Staff Report

To: BOZAR
From: Jessie Earley, Town Planner III
Meeting Date: BOZAR, May 27, 2025
RE: 75 Pyramid Way, Final Review

PROJECT TITLE: Guidone (75 Pyramid Avenue)

SUMMARY: Consideration of the application of **Franklin D. Guidone and Elizabeth A. Guidone** to site a single-family residence and two accessory buildings (one cold and one heated) to be located at 75 Pyramid Avenue, Lot T3, Slate River Subdivision in the R1F zone.

4/21 DRC: Proposed Site plan

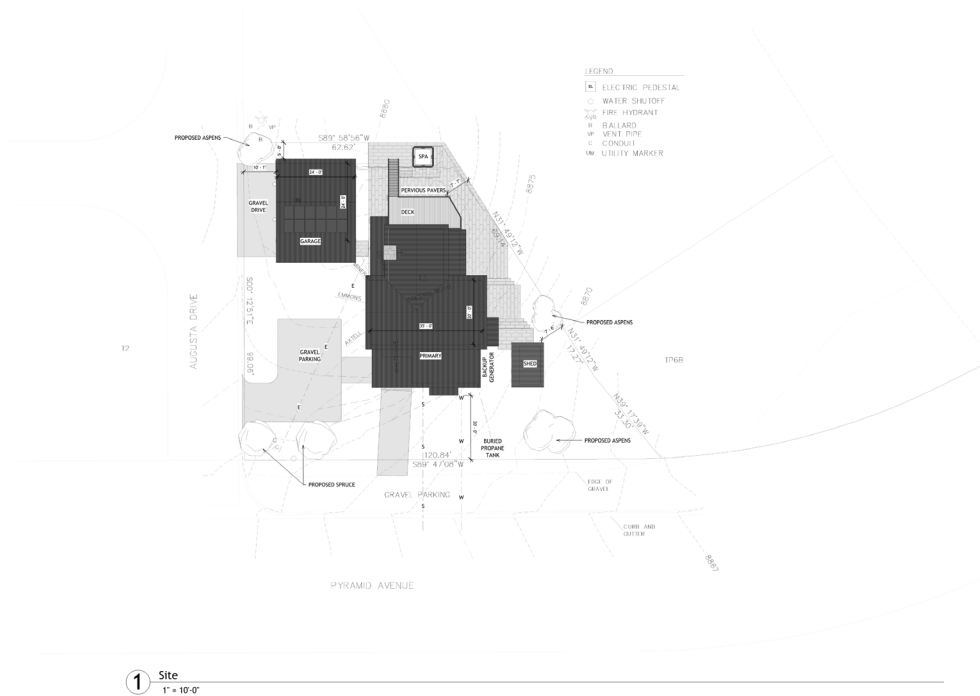
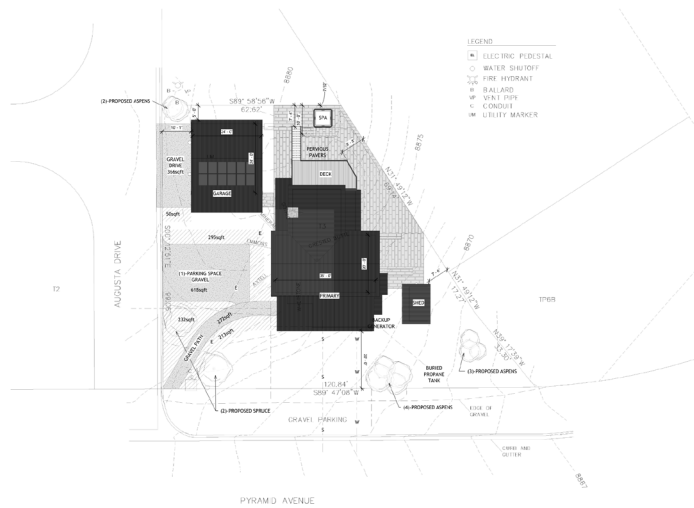
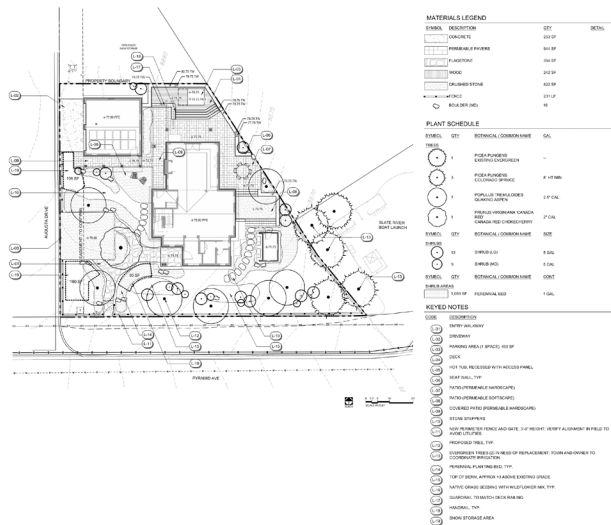
2.8 Drainage	<p>Drainage information has not been provided. Drainage arrows for the site must be shown.</p> <p>A drainage plan will be required. Confirmation of if a dewatering well will be required, is needed.</p> <p>During construction, stormwater</p>	Add information to plans

management and erosion control will be required in an overall construction management plan.	
Easements	<p>There is a 10' utility easement for the west side of the lot. This must be included on the site plan. This line has been included on the landscape plan, which was provided.</p> <p>There is an irrigation line on the south side of the south property line within the ROW. The propane tank must be shown at least 5' away from this. This line is shown on the landscape plan.</p>	Add information to plans.

The trees on the south property line must be shifted to be fully within private property. The trees proposed on the northwest corner must be removed from the utility easement.

2.16 a./ 2.20 Native plantings	Ground cover is noted as native grass mix. Native materials are encouraged by the GL. Support.	
2.16 e Pervious materials 2.28 e & f Parking substrate	<p>Walkway (354 sf) is noted as flagstone. Parking and west/east patio area (822 sf) are noted as crushed stone. The area on the south was decreased to accommodate one car, as the code requires. There is an area of concrete for the garage drive/entry (253 sf).</p> <p>The patio on the north and west and walkway between buildings (944 sf) is noted as pervious pavers. Then there is an area of wood on the northeast corner of the lot for a deck/hot tub (242 sf). This area is a large amount of hardscape. Discussion is encouraged. It is appreciated that this material is pervious.</p>	<p>4/21 DRC: Members encouraged revisions to the walkway on the southwest corner to ensure that this is seen as the front.</p> <p>Members discussed the amount of hardscape and said that this will likely be discussed at the full Board meeting.</p> <p>5/12 DRC: Members appreciated the more detailed landscape plan. This will be discussed with the full Board.</p>

- Updated site surfaces to more closely represent the SCJ landscaping plan: New wood deck and reduced pervious paver area

5/12 DRC: Revised Southwest perspective

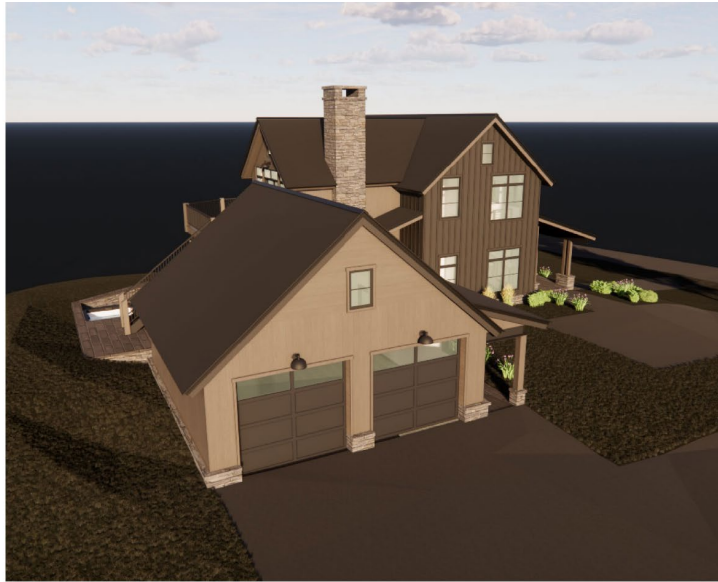
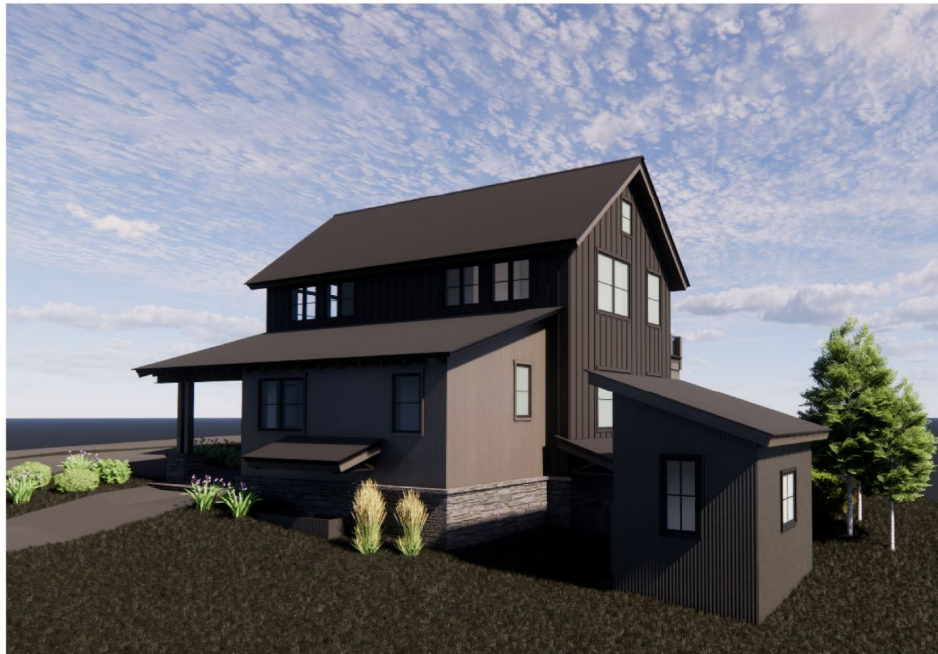
GL	Staff Analysis	DRC Recommendation
4.71 Chimney	The chimney appears large and oversized as seen from the west. The top is 3’4”, as seen from the north and east. Then it steps up to 7’1” at the base. Discussion is encouraged. The applicant has noted that this is what is required by code. A comparison of two other approved projects have been provided in plan view by the applicant. They have also provided comparison photos that they will overview in their presentation.	4/21 DRC: Members voiced concerns regarding the chimney as proposed. 5/12 DRC: Members again discussed the chimney and encouraged reduction. The owners would like the chimney to remain, as proposed.

- The fireplace and chimney have been reduced to minimum allowable dimensions for a Rumford 1500 unit.
- The southern window well has moved to the East side of the primary. This window well move allowed the primary residence to move 2' South on the site.
- The steel beams have been changed to wood beams.
- The horizontal siding has been removed at the gable ends sided with Board & Batten.
- 2" trim added under transom windows.

4/21 DRC: Elevations

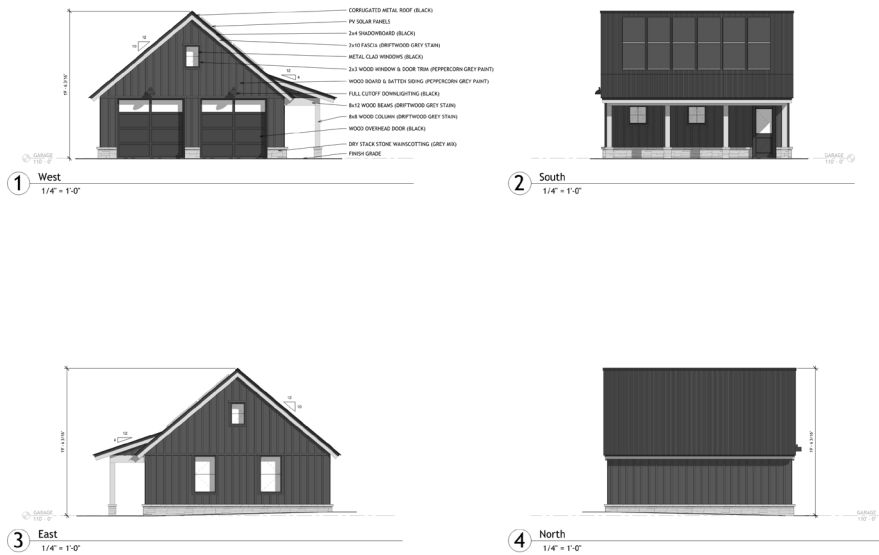
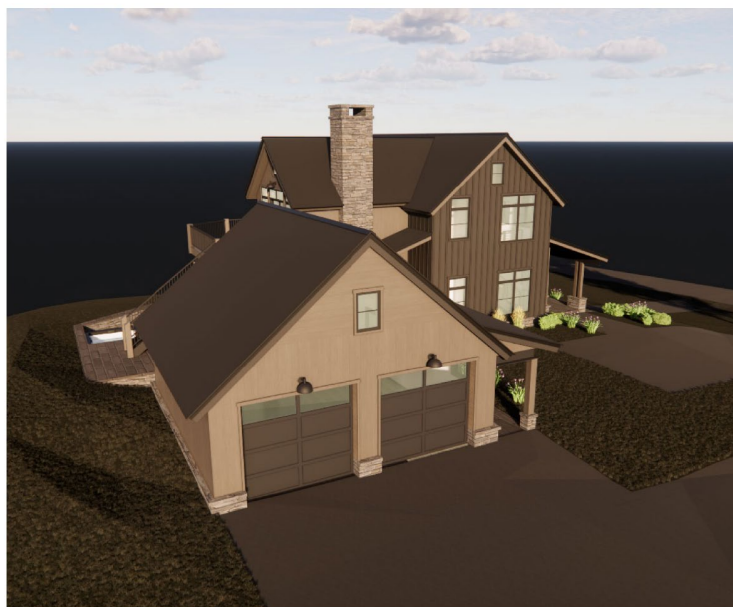
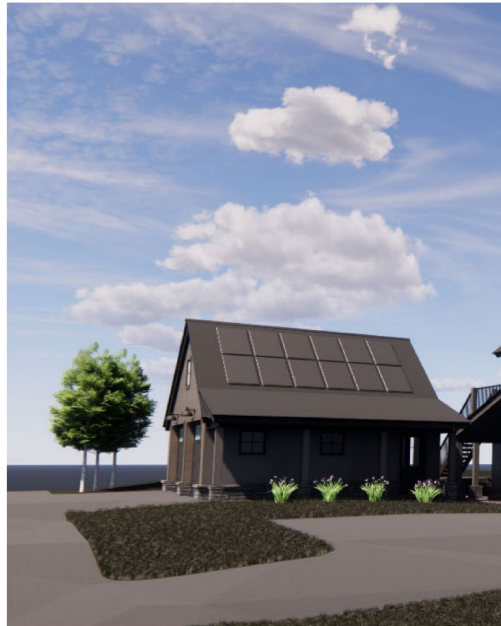
Accessory building mass/scale/form and placement (garage): Refer to GL 4.84-4.86, 4.89;
The proposed north accessory building is an 24'x24' gable module. The main module has a 10:12 pitch with a 4:12 small shed porch roof on the south. This must be a cold building due to the size, as proposed.

GL	Staff Analysis	DRC Recommendation
4.84 Smaller in size	The proposed building is smaller in scale than the primary building, as requested by the GL.	Support
4.85 Rear of the site	This building is located on the rear/north	Support
4.86 Vary appearance	This is the first accessory building within this zone. So, the context is being developed.	Support
4.89 d. porches	The small, covered entry for this building can be supported.	Support

4/21 and 5/12 DRC elevations

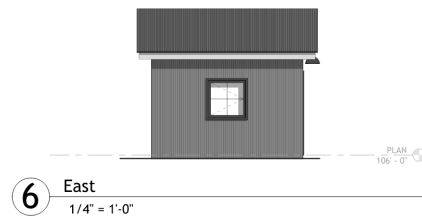
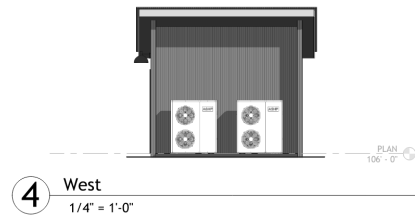
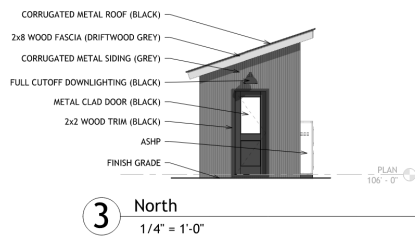
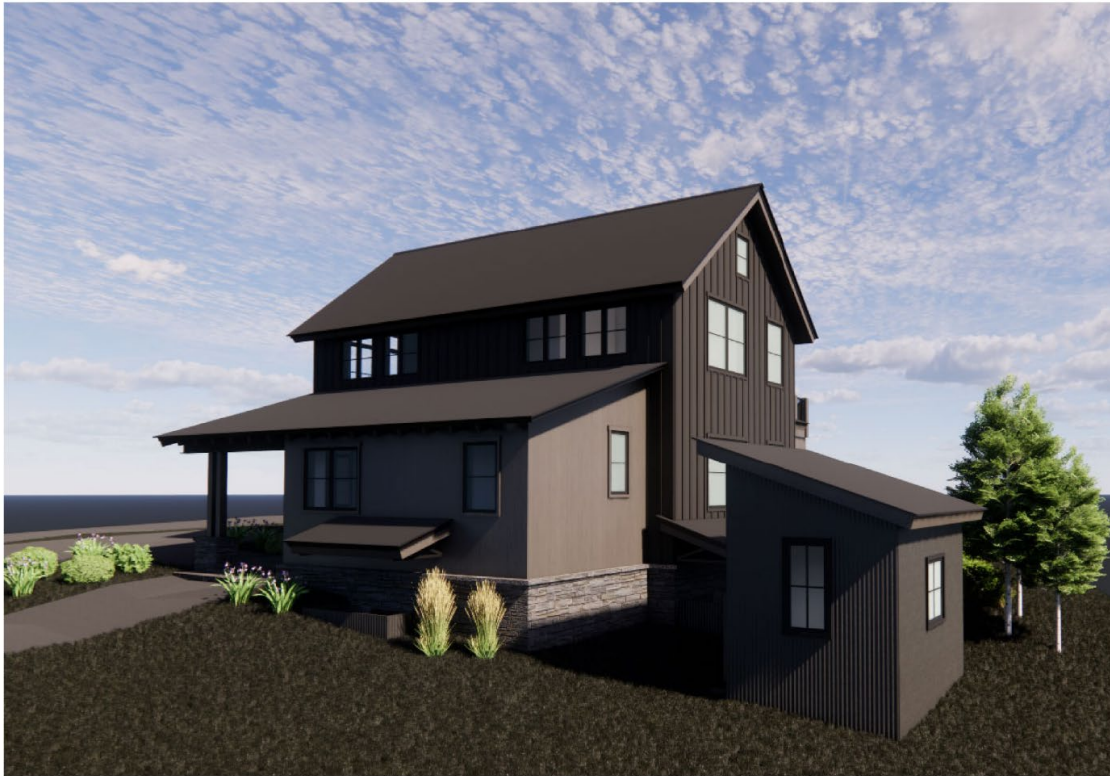
The proposed south accessory building is a 8'x12' simple shed building. The main module has a 4:12 pitch. Confirmation is needed if this will be a heated structure.

GL	Staff Analysis	DRC Recommendation
4.84 Smaller in size	The proposed building is smaller in scale than the primary building, as requested by the GL.	Support
4.85 Rear of the site	This shed is pushed back 2'6" from the front of the building. There are similar situations within the Paradise	Support

Park area. This lot is unique and presents challenges for access.	
4.86 Vary appearance	As seen in the perspectives, this building will vary in appearance from other buildings on this portion of the block.	Support
4.89 d. porches	The small, covered area for the air source heat pumps for this building can be supported.	Support
